CITY OF BULLHEAD CITY, ARIZONA
PUBLIC WORKS DEPARTMENT

CITY CENTRE IMPROVEMENT DISTRICT

PROJECT NO. 26-PW-002

ADDENDUM No. 2

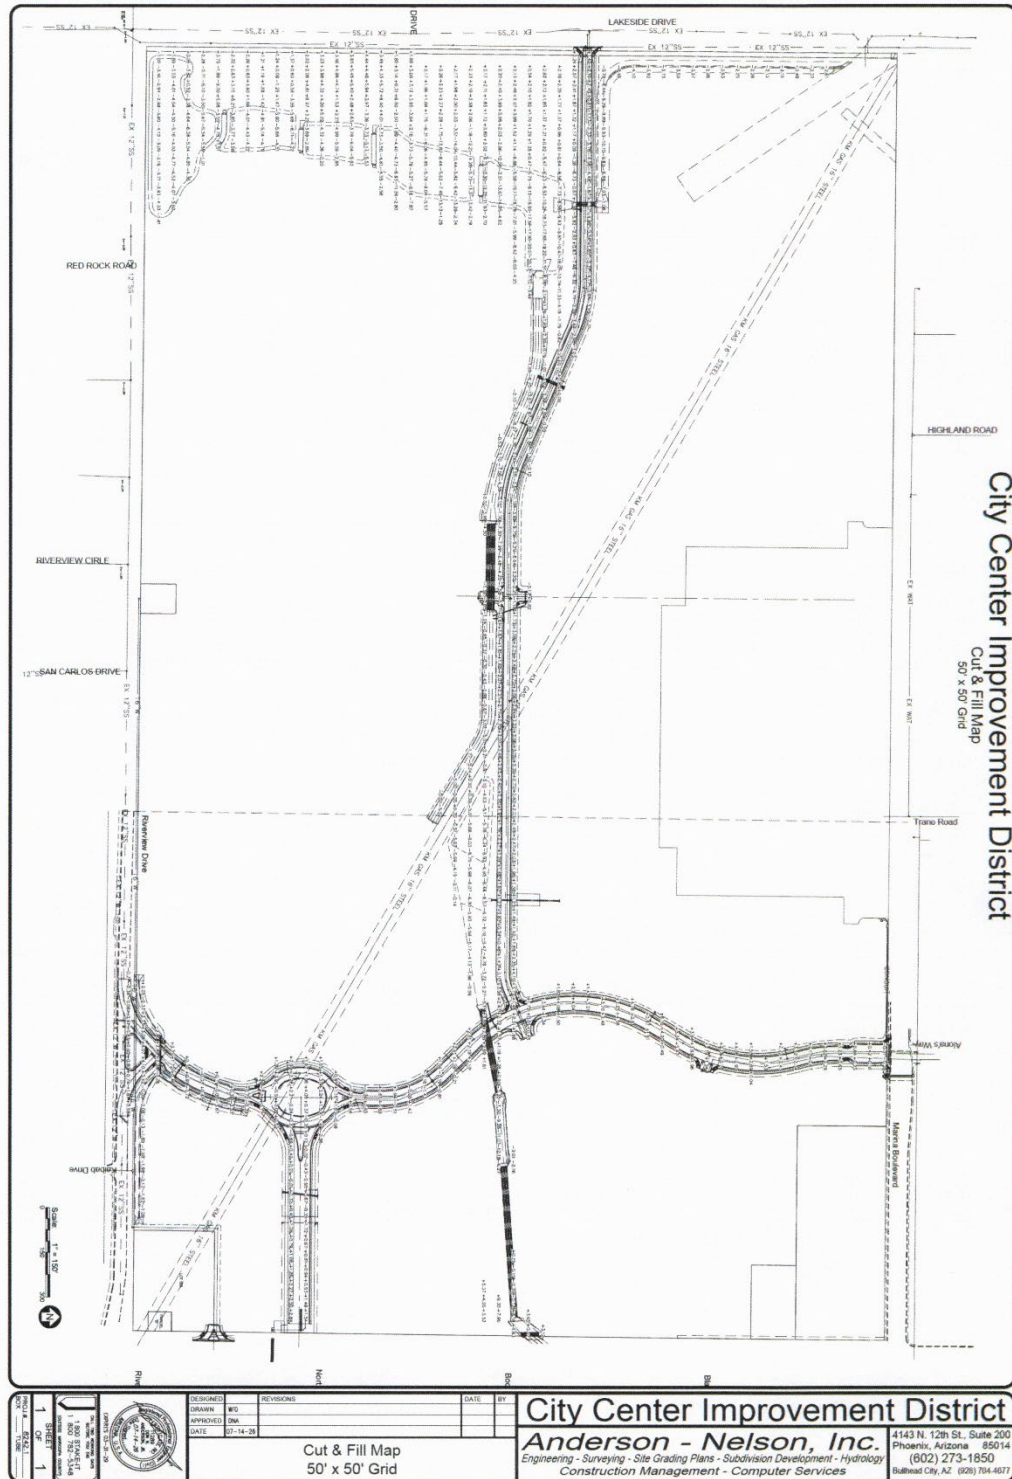
16. Is a soils report available? **A Geotechnical Report for a portion of the area is available upon request.**
17. Please confirm you only want a 6' Gate in the wrought iron fence on page 13.

The gate at the terminus of the channel on Sheet 13 should be a dual 6 foot gate, total 12 feet wide opening.
